TECHNICAL BULLETIN

DATE: 11 NOVEMBER 1997

ALTERNATE NUTPLATE INSTALLATION

All McDonnell Douglas Helicopter Systems (MDHS) MD900 Series Helicopters.

Figure 1. Alternate Nutplate Installation

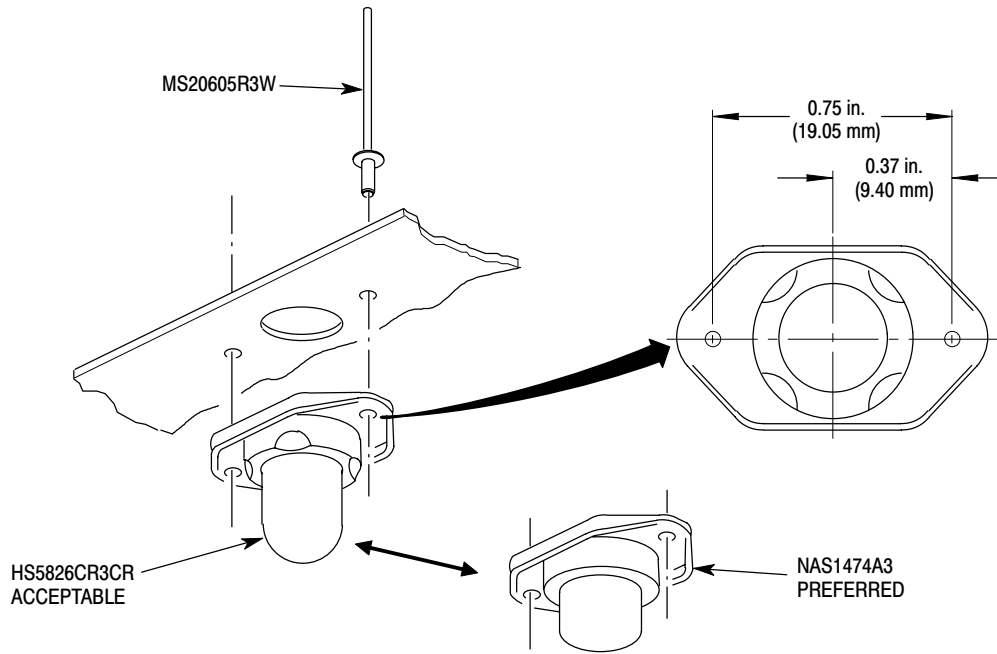
This Bulletin provides operators with a procedure to replace bonded HS5826CR3CR nutplates that have become unserviceable. Nutplates may be replaced in any location with an alternate nutplate and rivets. If the original nutplate has disbonded, and is otherwise serviceable, it may be drilled and reattached with rivets.

The NAS1474 nutplate has a cap height 0.222 in. (0.56 mm) less than the HS5826 nutplate, and requires the installation of a shorter screw or the addition of washers.

NOTE: This procedure describes replacement of an HS5826CR3CR nutplate with a new NAS1474A3 nutplate. If the original nutplate has become disbonded, and is otherwise serviceable, it may be reinstalled with rivets. Step 1 and Figure 1 provide information for drilling of the original nutplate for the use of rivets.

- Do not cut or sand into or expose graphite/epoxy fibers.
 - Do not use aluminum oxide abrasives on graphite/epoxy materials.
- (2). Remove old nutplate if installed by carefully cutting baseplate away from adhesive.
 - (3). Lightly sand to remove remaining adhesive with sandpaper (C807).
 - (4). If reusing old nutplate, drill two 0.098 inch (2.49 mm) holes through baseplate of nutplate 0.37 inch (9.39 mm) from the center. Deburr holes.
 - (5). Matchdrill holes in nutplate to attachment structure.
 - (6). Countersink rivet holes 100°.
 - (7). Vacuum area and remove masking.

(9). Secure nutplate to structure with rivets. Install rivets wet with primer (C310) .

- (10). If nutplate is an any engine firewall build up assembly component, seal rivets with sealing compound (C215). In all other areas seal rivets with sealant (C216). This is to prevent vapors, fluids, etc. from entering area beyond nutplate.
- (11). Record compliance of this Bulletin in the compliance record section of the helicopter log book.
